Mask Set Errata 1

MC68HC12D60 Microcontroller Unit

This errata provides mask-set specific information applicable to the following MC68HC12D60 MCU mask set devices:

- 0K13J

Figure 1. Representation of Normal start-up condition

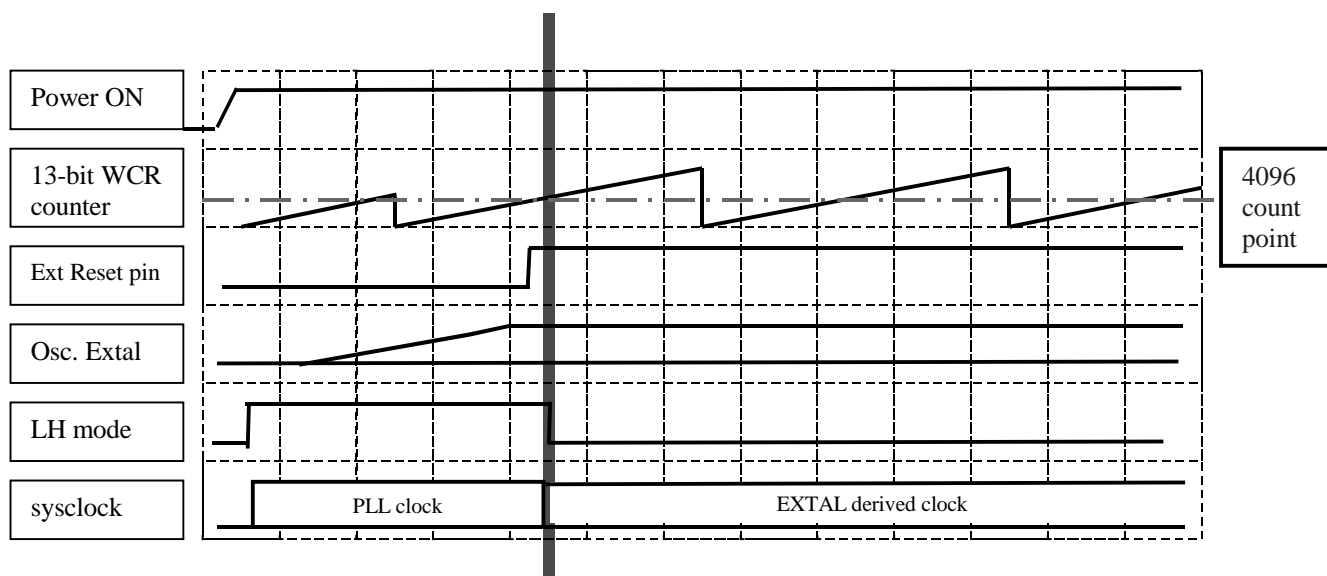
Common practice for the start up mode of operation of HC12 microcontrollers is for the external RESET line to be held active until such time as the crystal has

stabilized at its operating frequency. On release of the external RESET line and when the WCR (counter register) reaches a count of 4096 cycles, normal operating mode is entered with the CPU clocked from the crystal frequency (see fig. 1).

Figure 2. Representation of unreliable start-up mode with slow crystal

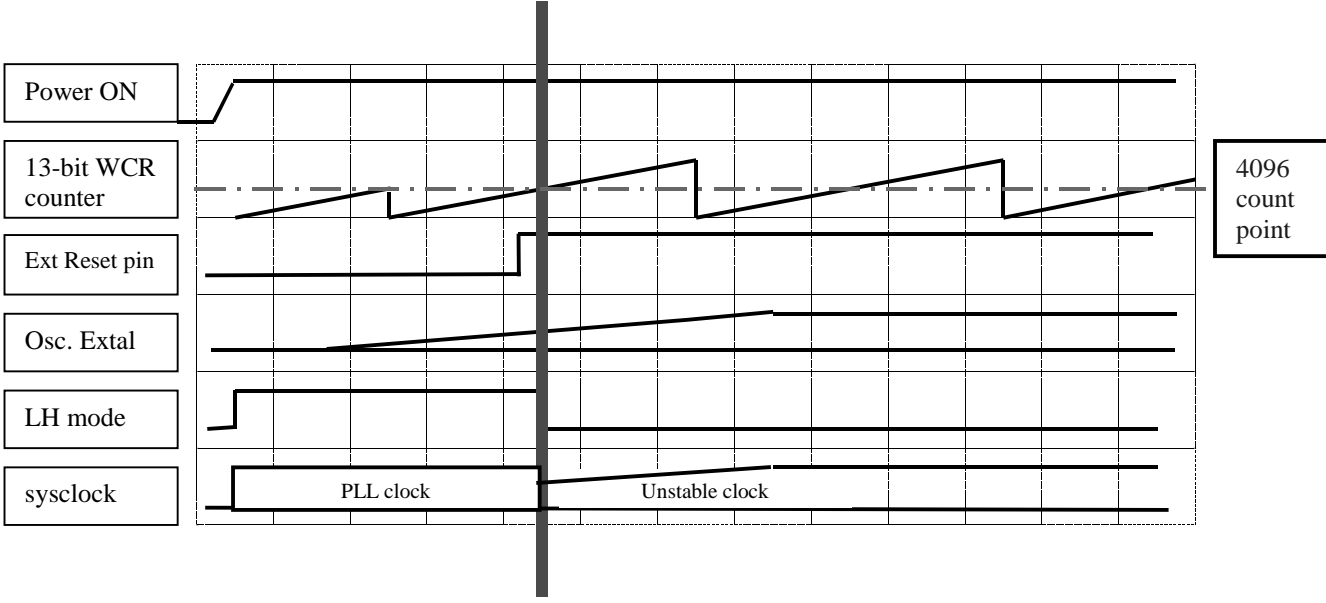
The HC12 mode of operation known as Limp-Home Mode (LHM) is enabled when the VDDPLL pin is at VDD and is entered if for any reason the external crystal ceases to oscillate. During this mode the CPU will be clocked from the free-running VCO clock of the PLL (at a nominal frequency of 1MHz). If LHM is enabled during the start-up phase (i.e. VDDPLL=5V, NOLHM bit=0) and the external RESET line is not held active until after the crystal frequency is stable then the device starts up in LHM since no crystal oscillations will be detected. This situation can arise with short reset periods and/or crystals that exhibit slow start-up characteristics.

For the first 4096 cycles i.e. during the internal reset period, Limp Home mode will be de-asserted if oscillator activity is detected by the clock monitor circuit -due to the asserted Reset signal there can be no CPU activity during the Reset phase. Following release of the external or internal POR RESET in LHM (which ever is later) the crystal oscillator is sampled by the clock monitor circuit after another 4096 VCO clock cycles and at intervals of 8192 clock cycles thereafter until the crystal is deemed to be operating. If the crystal oscillator is showing activity at the time it is checked then it will be deemed to be good, even though it may not have fully stabilized, and LHM will be de-asserted. This can cause the device to switch from LH mode to normal mode with the CPU clocked from an unstable signal from the crystal oscillator (see fig. 2) resulting in unpredictable function of the CPU.
